**BUNCOMBE COUNTY
GENERAL SERVICES DEPARTMENT
40 McMORMICK PLACE
ASHEVILLE, NC 28801
(828) 250-4235**

BID DATE: Monday, November 20, 2023
DATE OF ADDENDUM: Thursday, December 14, 2023
ADDENDUM NUMBER: A

**SPORTS PARK - NEW RESTROOM BUILDING &
WATERLINE EXTENSION
BUNCOMBE COUNTY, NORTH CAROLINA**

Sheet
C4

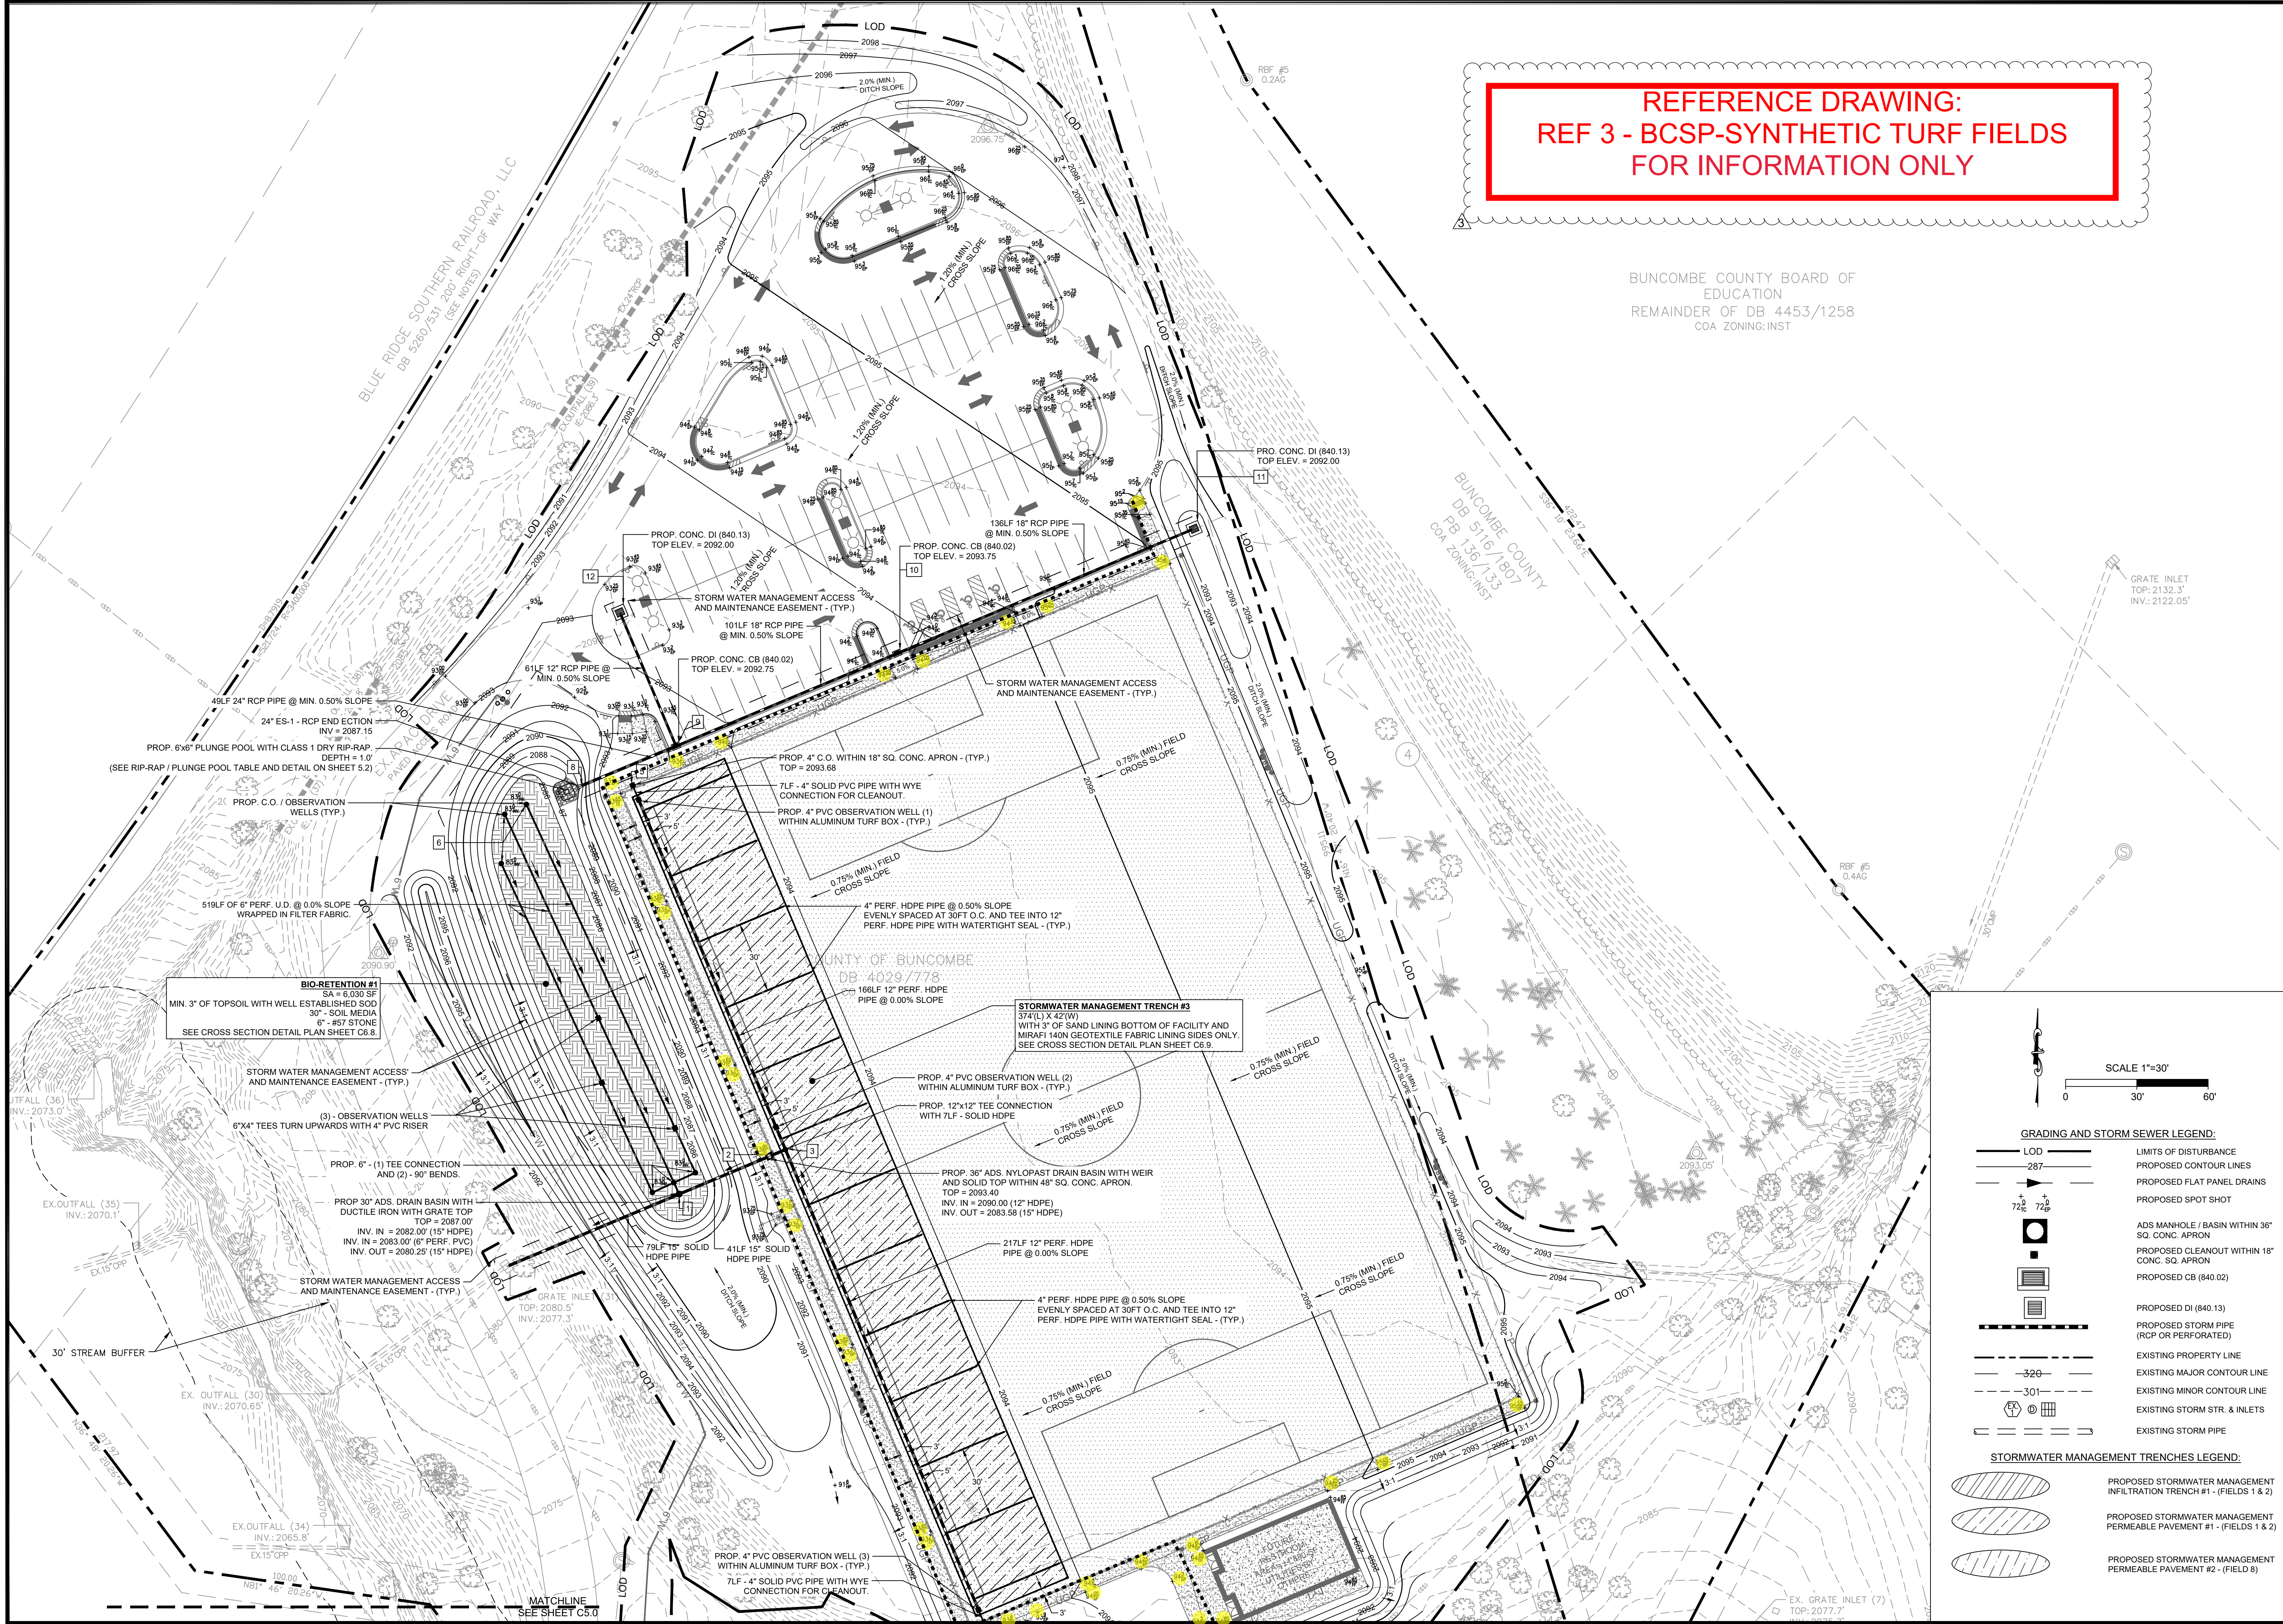
- Item 3 - **Revised (C4)**. Remove “Construction Access Gravel Road” shown on the west side of the proposed restroom facility. The Construction access is shown on sheet G100 in the Contractor Use of Site Plan and is to run parallel to the east side of the field.

3 ADDENDUM A 12-14-2023
 REMOVED ACCESS ROAD
 SEE SHEET G-100 CONTRACTOR USE OF SITE PLAN

FIRST FLOOR REFLECTED CEILING PLAN
SCALE: 1/4" = 1'-0"

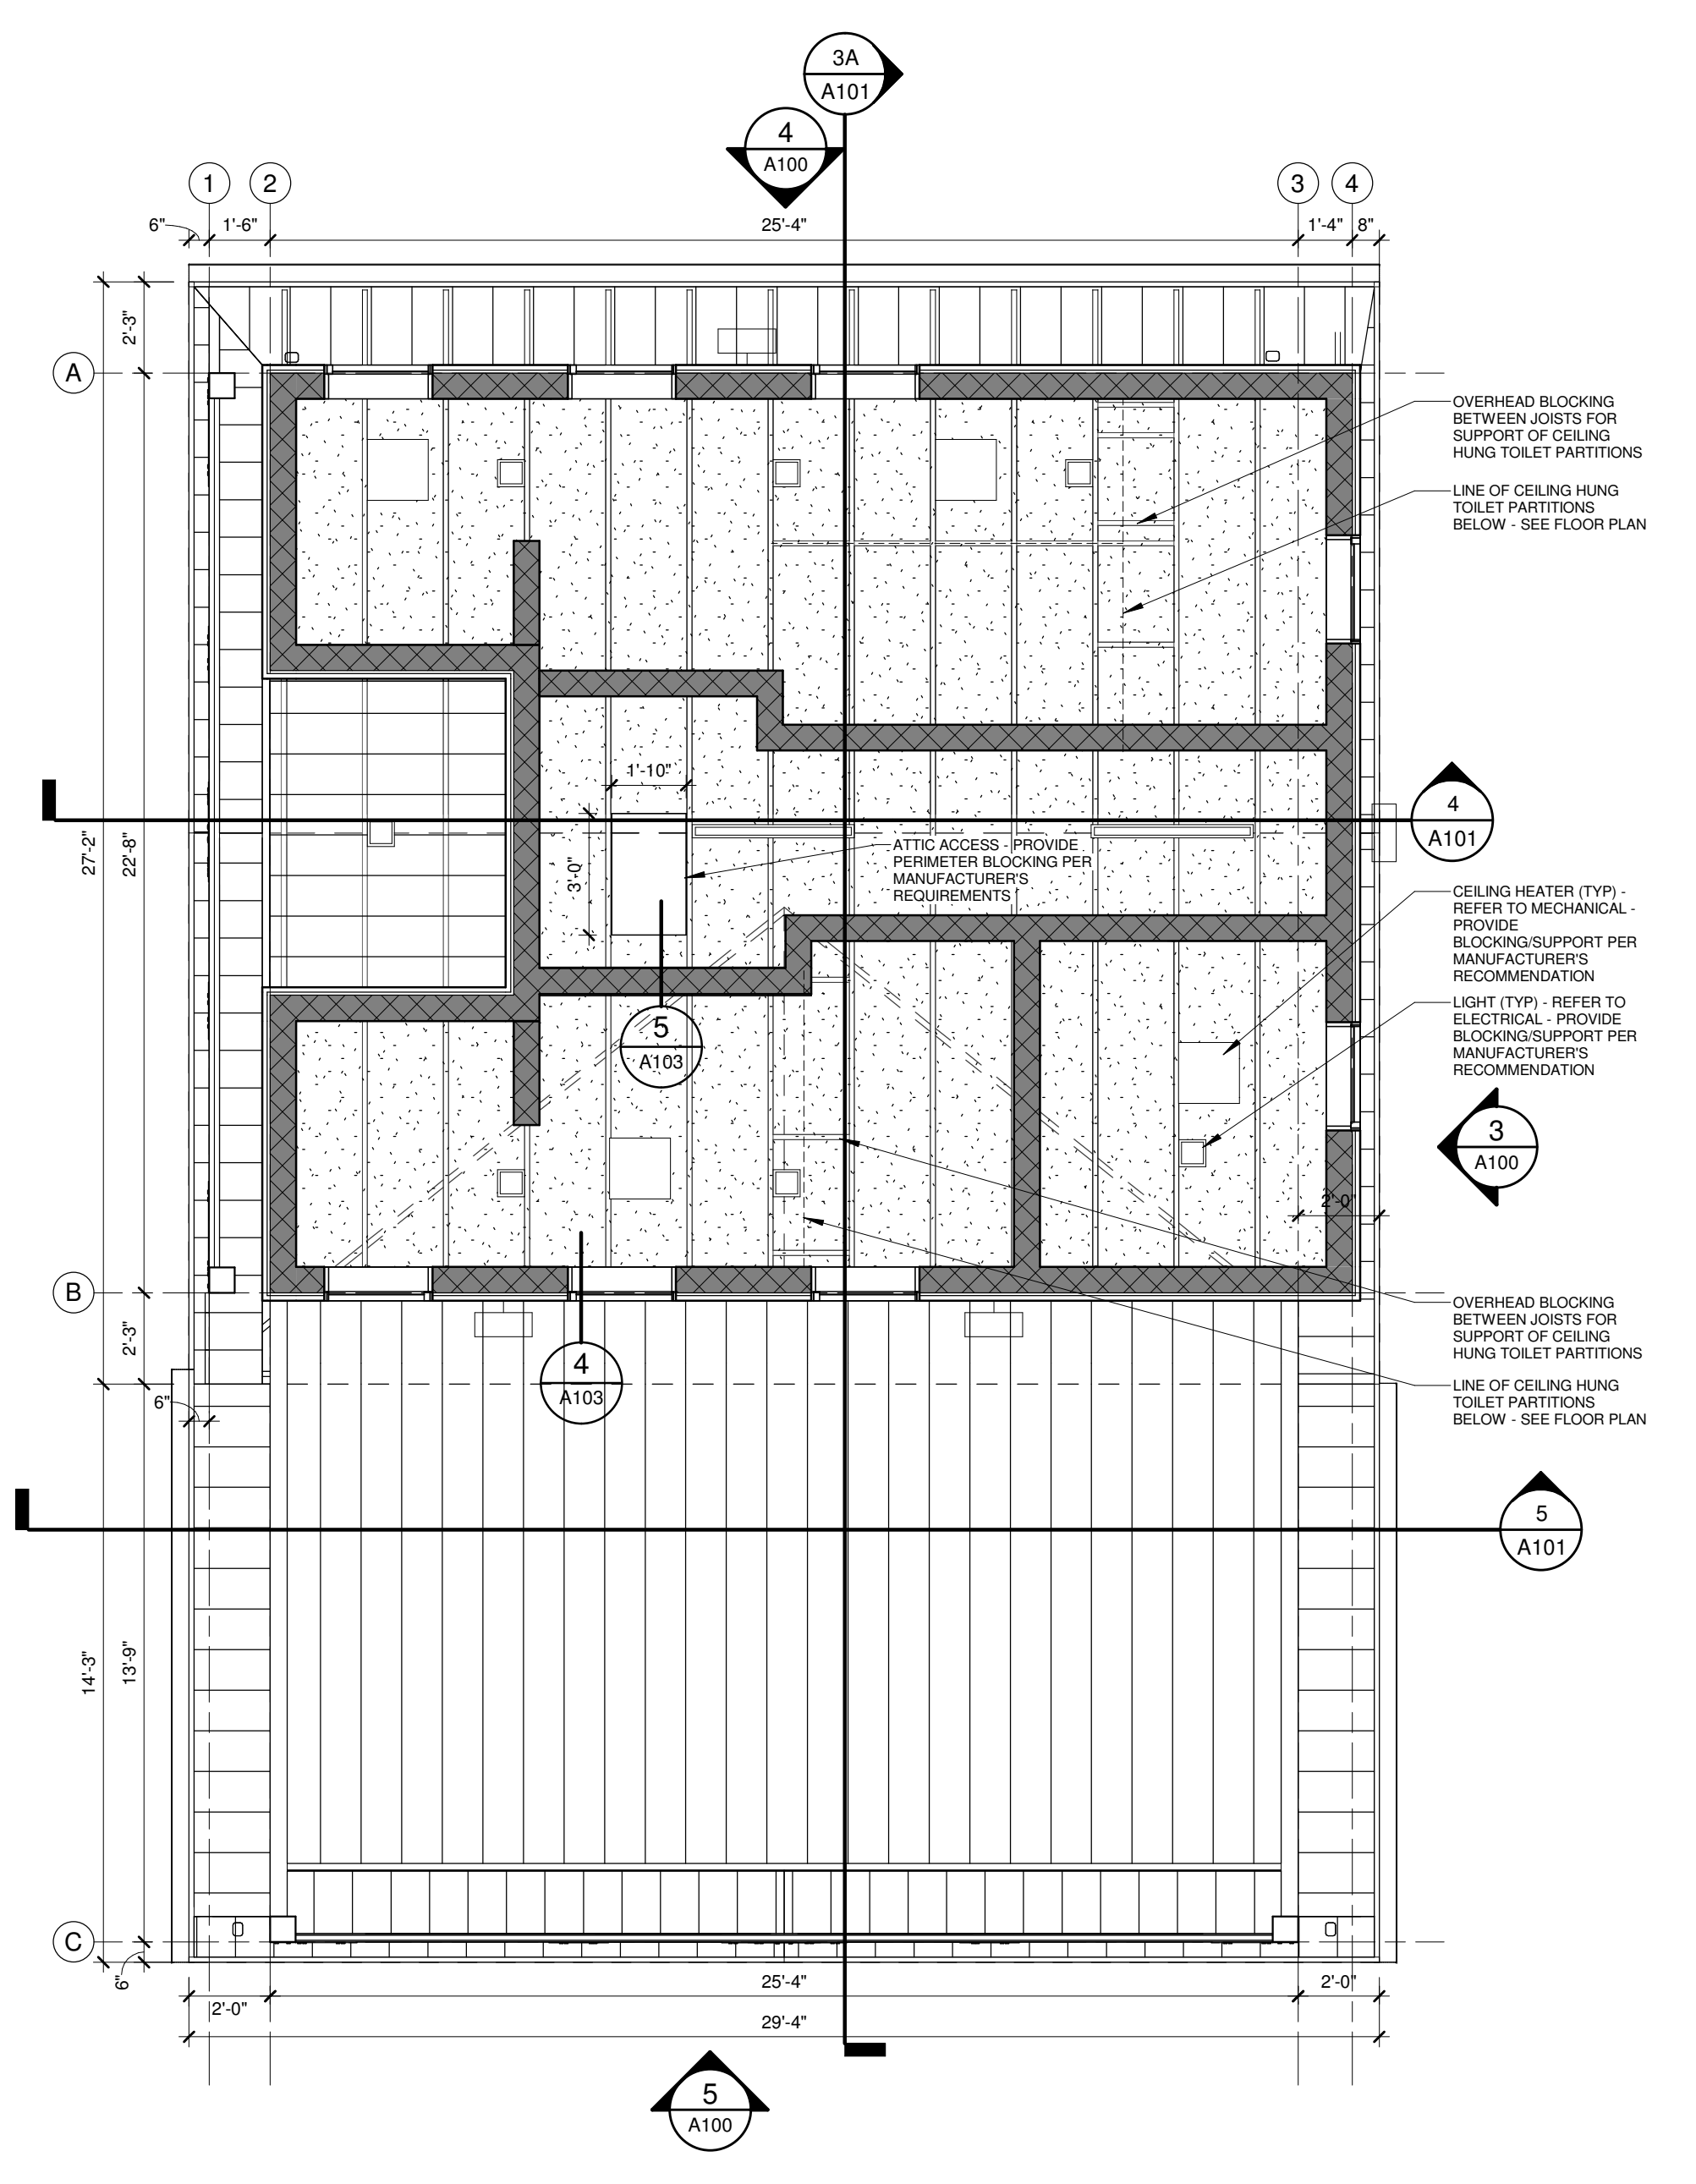
- Item 8 - Revised (A101). Ceiling Plan Legend revised to Finished Fiberglass Mat Faced Gypsum Board Ceiling in lieu of Cement Board Ceiling.
 - Item 9 - Revised (A103). Added door hardware sets. Updated Finish Legend and General notes.
 - Item 10 - Revised (P1). Site plan added for reference.
 - Item 11 - Revised (P2). Water pipe sizes clarified.
 - Item 12 - Revised (P3). Detail clarification.
 - Item 13 - Revised (M2). Modified a wall heater location and the inline exhaust fan location to avoid interference from the plumbing chair carriers.
 - Item 14 - Revised (E3). Added a site plan for reference and the existing panel schedule where the hot box heater is powered.
-
